ADDENDUM NO. 1

**ROSELLE PARK DISTRICT
GOOSE LAKE PARK PATH REPLACEMENT PROJECT
ROSELLE, ILLINOIS
MAY 19, 2026**

PCC PATH DETAIL
N.T.S.

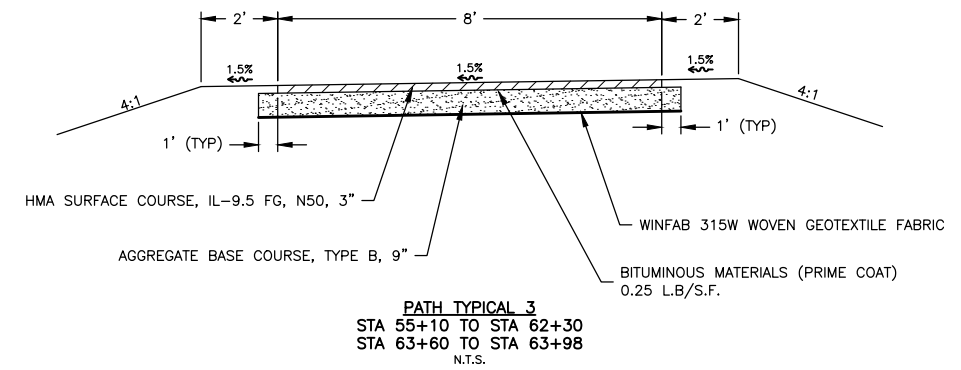
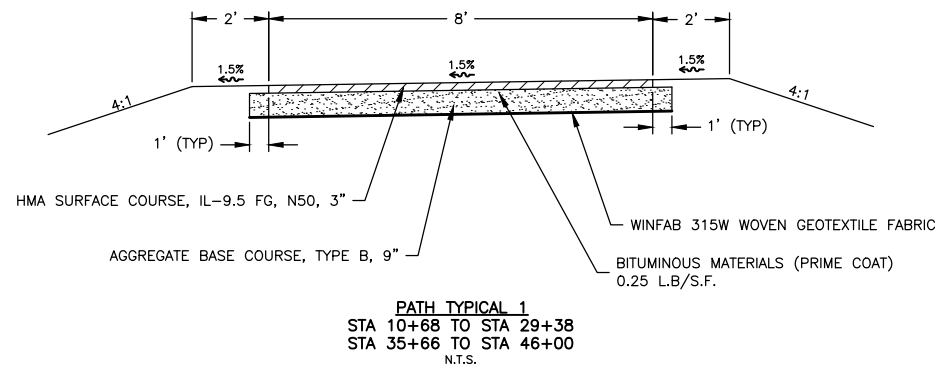
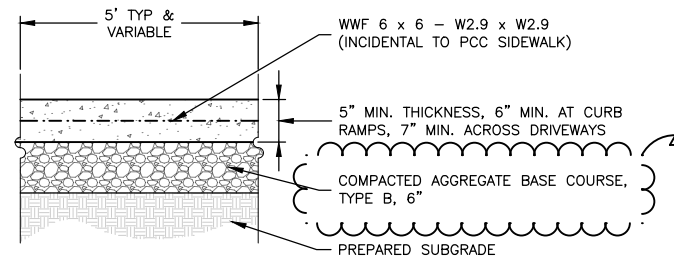
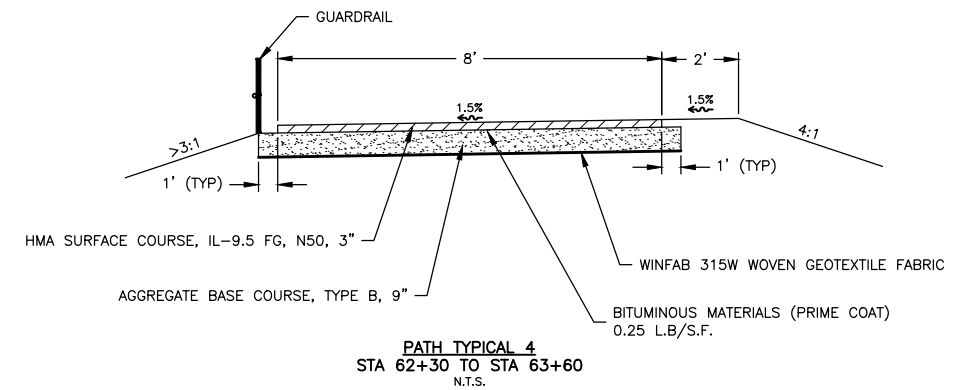
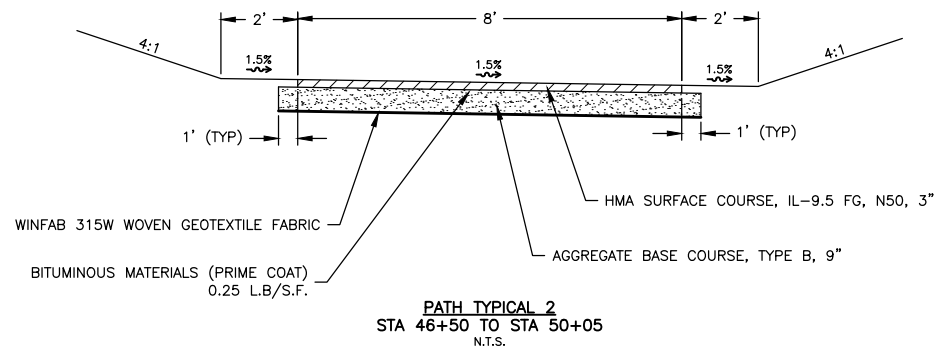
- Sheet 5 of 46, "Typical Cross Sections," has been revised to clarify that aggregate base course for the PCC path/sidewalk is not incidental to the PCC Trail pay item and shall be paid under the applicable aggregate base course pay item.
- Sheet 5 of 46, "Typical Cross Sections," has been revised to add a note regarding approximately 150 tons of Owner-furnished aggregate base course available from the Roselle Park District for use on the project.

NOTE: OWNER-FURNISHED AGGREGATE BASE COURSE

THE ROSELLE PARK DISTRICT HAS APPROXIMATELY 150 TONS OF AGGREGATE BASE COURSE AVAILABLE FOR USE ON THE PROJECT. THE MATERIAL MAY BE USED FOR AGGREGATE BASE COURSE UNDER THE HMA PATH AND/OR PCC PATH/SIDEWALK, AS APPROVED BY THE ENGINEER. OWNER-FURNISHED AGGREGATE INCORPORATED INTO THE WORK WILL BE MEASURED AND DEDUCTED FROM THE APPLICABLE AGGREGATE BASE COURSE PAY ITEM. SEE ADDENDUM NO. 1 FOR ADDITIONAL REQUIREMENTS.
